# Access Compliance Report

## Public Rights-of-Way

### (Curb Ramps)

Intersection ID: 42988	Main Street: UNIVERSITY_CITY_BV	Cross Street: N/A	Location: S
ADA ID: 9C4BD463DAEE	Ramp Type: Para	Initial Pass/Fail: Fail	Overall Compliance: No
Severity Score: 12.5			
Codes/Mitigation Info/Possible Solution		Field Measurements/Component Compliance

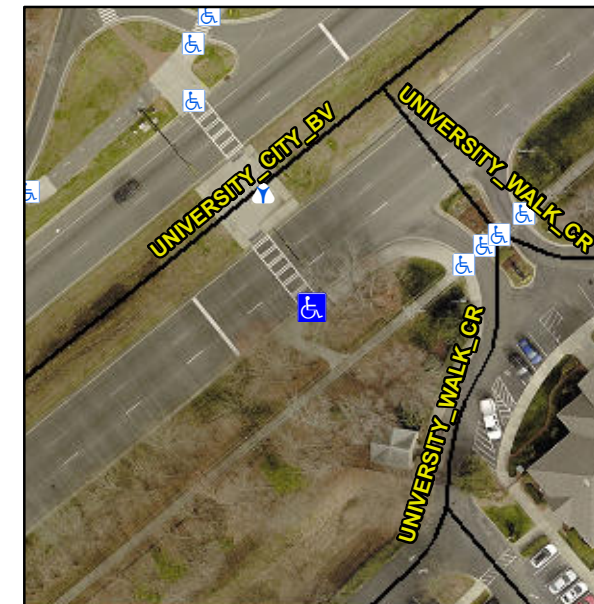
Surveyor Notes:

**LT RP < 5%**

PROW/ADA:

**R304.3.2**

Possible Solutions:

**Remove & Replace Entire Ramp.**
